**Re: 929 Richmond Road Transportation Impact Assessment
Addendum #1**

The Transportation Impact Assessment (TIA) for the proposed residential development located at 929 Richmond Road was submitted in December 2017. Comments have been received on the TIA from the City of Ottawa and the Site Plan has been revised. This Addendum #1 has been prepared to address the City's transportation comments. The revised Site Plan is included as Attachment #1.

Figure 1: Proposed Pocket Northbound Left-Turn Lane at Site Driveway

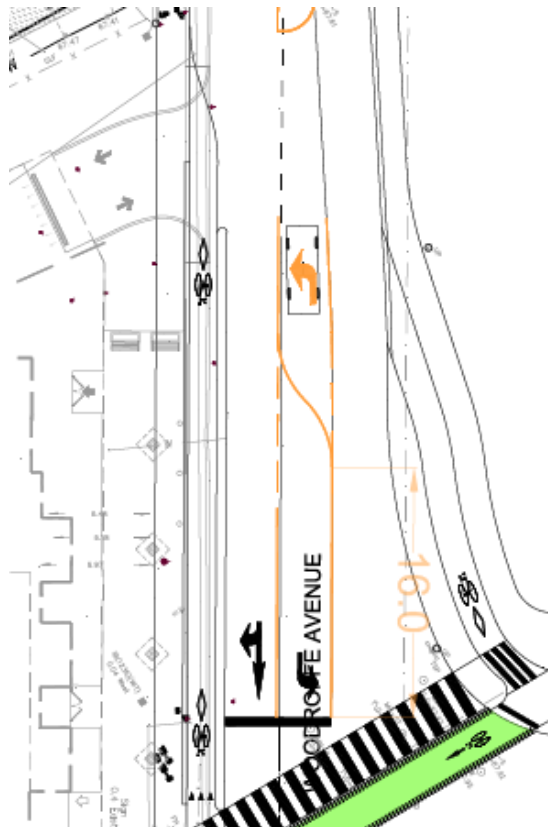
Comment 13: The southbound queues will block the access off Woodroffe Avenue. Vehicles waiting to turn left into the access will block Woodroffe Avenue traffic and resultant queues may block pedestrian crossing, cycle tracks, and

extend into the intersection. Was there any analysis completed for the site access to determine effect on through traffic?

Response 13: As outlined in the original TIA, there are approximately 20 veh/h projected to turn left into the site during the afternoon peak hour. There is a significant amount of queueing in the southbound direction on Woodroffe Avenue and we have been informed by the public that vehicles do not always leave gaps in traffic to allow left-turn movements along this corridor. It is noteworthy that the SYNCHRO analysis assumes that drivers leave gaps in the southbound queue and the northbound left-turn movement into the site operates acceptably in the SYNCHRO model. The following mitigative measures are offered to improve operations at the site driveway:

1. Provide pocket northbound left-turn lane at site driveway:
 - The existing southbound left-turn lane at the Richmond/Woodroffe intersection is approximately 30 m long plus taper. This option is to remove a portion of the southbound left-turn storage length and provide a short northbound left-turn lane at the site driveway. This will allow the northbound through movement on Woodroffe Avenue to flow freely even if there is a left-turning vehicle entering the site;
 - This proposed shortened left-turn lane configuration is illustrated below and provided as Attachment #3.

- As shown, if a 16m southbound left-turn lane is provided at the Richmond/Woodroffe intersection then short pocket left-turn storage lane could be accommodated at the site driveway. There are approximately 30 to 50 southbound left-turning vehicles per hour at the Richmond/Woodroffe the morning and afternoon peak hours. According to TAC guidelines, this amount of traffic warrants a 14m storage lane (assuming the existing 100 second cycle length). The southbound left-turn phase is permitted (i.e. no advance left-turn arrow). This option allows the northbound left-turn movement into the site without impacting the northbound traffic flow along Woodroffe Avenue.
